## C2PC Letter

We, Shenzhen Jingwah Information Technology Co., Ltd. Want to apply for C2PC for FCC ID: RBD-CVR-255-64. The differences are as follows:

### VR Headset Difference statement

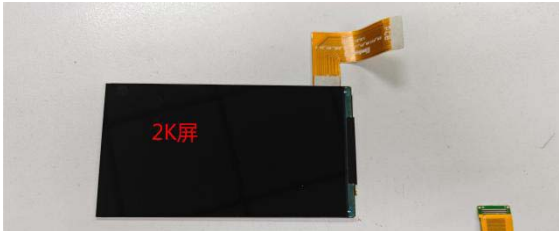
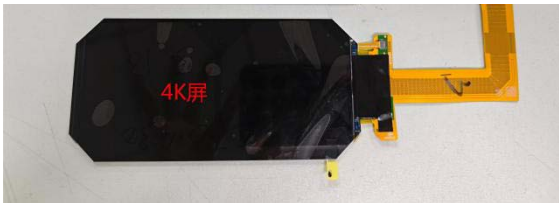
| Item | Difference                                    | Model(s)     | Detailed Differences                                                                                                                                                    | Picture                                                                               |
|------|-----------------------------------------------|--------------|-------------------------------------------------------------------------------------------------------------------------------------------------------------------------|---------------------------------------------------------------------------------------|
| 2    | LCD screen change                             | CVR-255-64   | <b>Use 2K LCD screen</b><br>Models: VS055QHM-NR0-69P0<br>Manufacturer: ORDOS YUANSHEG<br>OPTOELECTRONICS TECHNOLOGY CO.,<br>LTD.                                        |    |
|      |                                               | CVR-255-64-A | <b>Use 4K LCD screen</b><br>Models: LS055B3SX04Z<br>Manufacturer: Sharp Display Technology<br>Corporation                                                               |   |

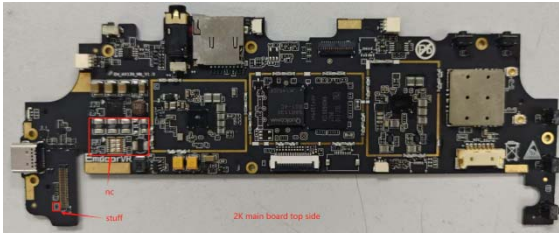
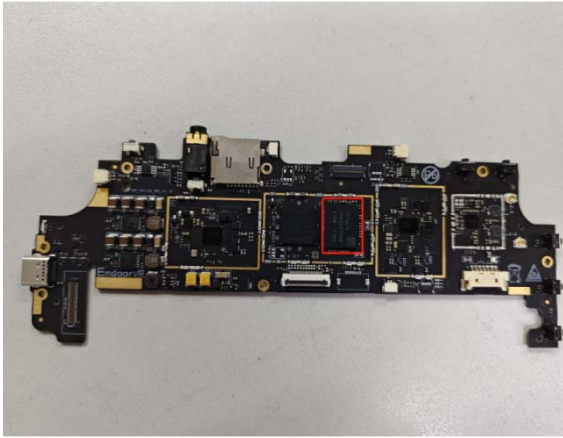
| Item | Difference                                    | Model(s)     | Detailed Differences                                                                                                                                                    | Picture                                                                               |
|------|-----------------------------------------------|--------------|-------------------------------------------------------------------------------------------------------------------------------------------------------------------------|---------------------------------------------------------------------------------------|
| 3    | Differences in LCD display circuit components | CVR-255-64   | <b>Display circuit components</b><br>The backlight circuit of the screen has one path without adhesive, and the configuration resistor of the screen has two adhesives. |  |
|      |                                               | CVR-255-64-A | <b>Display circuit components</b><br>Both circuits of the screen backlight circuit are                                                                                  |  |

|   |                                | CVR-355-128  | pasted, but there are 2 resistors in the screen configuration that are not pasted. |                                                                                       |
